SPIRE-RAL-COM-001508

Re: Updating information on PTC Harnessing for SPIRE HDD and SPIRE BDA to JFET HDD.

FPU F28

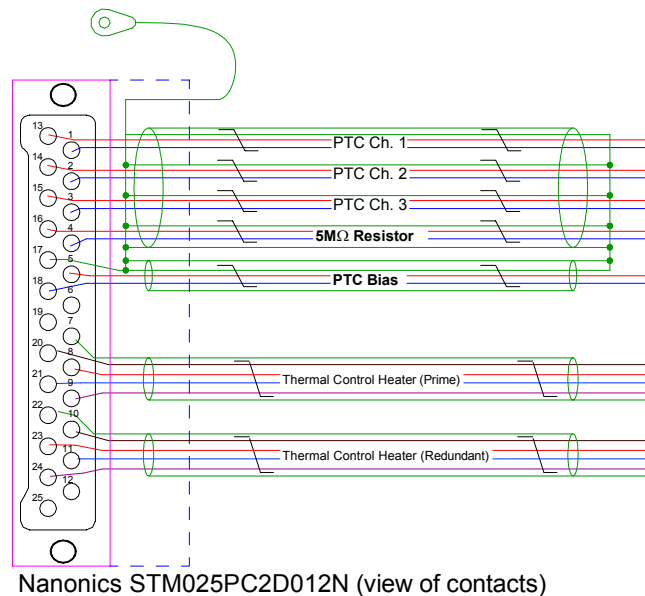
2. In the current version of the BDA-JFET harness document, the connector for the PTC is specified as a 21-way MDM. I propose to change this to a 25-Way Nanonics. This is because (a) the nanonics connector is smaller and lighter than the MDM. We need to minimise the mass of the components on the Spectrometer Detector Box, (b) there are tapped holes on the nanonics connector body that could be used to screw the connectors to the spectrometer detector box, (c) the dimensions of the connector are smaller, so it would be more easily accommodated on the spectrometer detector box. Could you please confirm that the pin allocation is OK? The above Figure will be inserted into the HDD 1.1 if it is OK.

3. I have included the ground connection between the harness and the detector box near the nanonics connectors shown in the above figures. This will be a tab that is screwed
